ED PIGOTT
MACDONA HEIGHTS SUBDIVISION

REVISED
P.O.A.D.P.

Re: Macdona Heights POADP
File #279

SUBJECT: CONSIDERATION OF POADP #279, MACDONA HEIGHTS SUBDIVISION

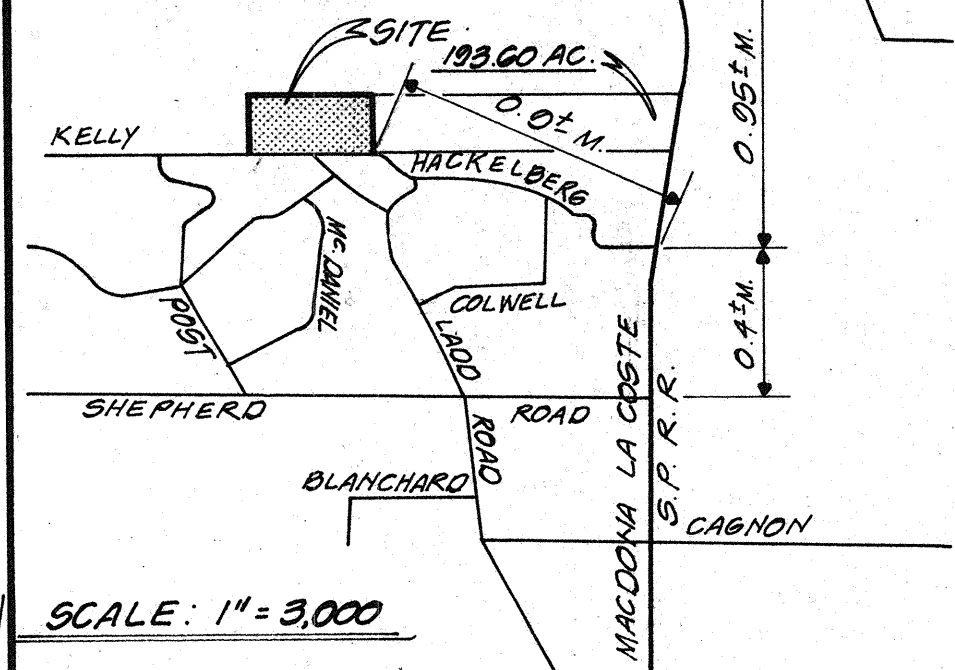
Please be advised that the Planning Commission at its meeting of March 16, 1988 accepted the above referenced plan reflecting the proposed street system to be built to County standards subject to the condition that the stub street be converted to a cul-de-sac street adjacent to Lot 53 & 54, Blk. 1. Therefore, please submit a new plan reflecting this change. Although the Commission has accepted the plan, it will be necessary to request a variance to the street construction standard at the time of plat consideration.

The staff cannot accept your plan as submitted as it does not meet the requirements for standard streets. The plan proposes 24' pavement widths with a two course surface treatment and 60' ROWs.

The Development Review Committee recommends that the proposed streets be built to the required standards as per the Unified Development Code. You may revise your plan or appeal to the Planning Commission for a final decision by submitting a formal written request to the Director of Planning.

In accordance with Section 35-2073 of the Unified Development Code, Mr. Mark Brown representing Mr. Ed Pigott is appealing to the Commission for approval of his POADP for Macdona Heights Subdivision. The plan meets all requirements of the subdivision regulations except for street standards. Mr. Pigott is proposing to construct his streets to County rather than City standards.

If the developer does not construct the streets to City standards, the City will inherit maintenance problems when the property is incorporated into the City limits. Additionally, the typical street section proposed is the minimum standard required by the County and in order to determine the proper design for construction, a soil test will be necessary. The Department of Public Works has indicated that the pavement section as proposed will rapidly deteriorate due to adverse weather, and with minimum traffic the pavement will fail at a faster rate.

It is therefore recommended that the plan be denied and that the streets are platted in accordance with City regulations.

- NOTES
- 1) DEVELOPER: MR. ED PIGOTT
ADDRESS: 2810 W. LOOP 410, SAN ANTONIO, TEXAS, 78227
TELEPHONE No: (512) 674-5721
 - 2) SEWAGE TREATMENT: SEPTIC TANKS.
 - 3) WATER SUPPLY: ATASCOSA WATER COMPANY.
 - 4) ZONING: NONE
 - 5) THIS PROPERTY IS NOT WITHIN THE 100 YEAR FLOOD PRONE AREA (ZONE A) AS PER FEMA COMMUNITY PANEL NUMBER 485493 0004 C DATED JUNE 17, 1986.
 - 6) TOTAL ACREAGE OF THIS P.O.A.D.P. IS 102.61 ACRES.
 - 7) STUB STREET IS CONVERTED TO A CUL-DE-SAC STREET TO COMPLY WITH PLANNING COMMISSION CONDITION OF APPROVAL MADE MARCH 16, 1988.

Enclosed for your records are two (2) copies of the referenced POADP revised to eliminate the stub street adjacent to Lot 53 and 54, Block 1. With these revisions the POADP should be in complete compliance with Planning Commission conditions of approval as granted on March 16, 1988.
